Energy Efficiency

Renewable Energy Systems

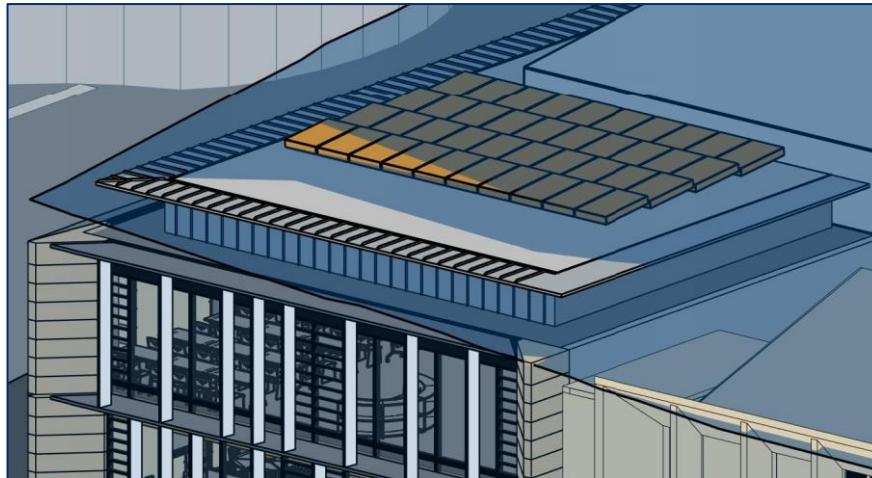
It is unclear from the plans and ESD Report as to whether any renewable energy elements are proposed as part of the School's masterplan.

It is requested that the applicant provide clarification as to whether any renewable energy elements (specifically photovoltaic or solar/heat pump hot water systems) are proposed for the masterplan and Stage 1 works.

The roof of the new Wilkinson House generally faces north, east and west with minimum shading from adjacent buildings. Photovoltaic cells are proposed to be placed on the areas as detailed in the figure below and will be installed within the building height control limits of the development. The panels will be tilted at an angle to maximise efficiency and be considerate of reflectivity/glare to neighbouring properties. Given the limited amenities within the building, solar hot water systems will not be installed.
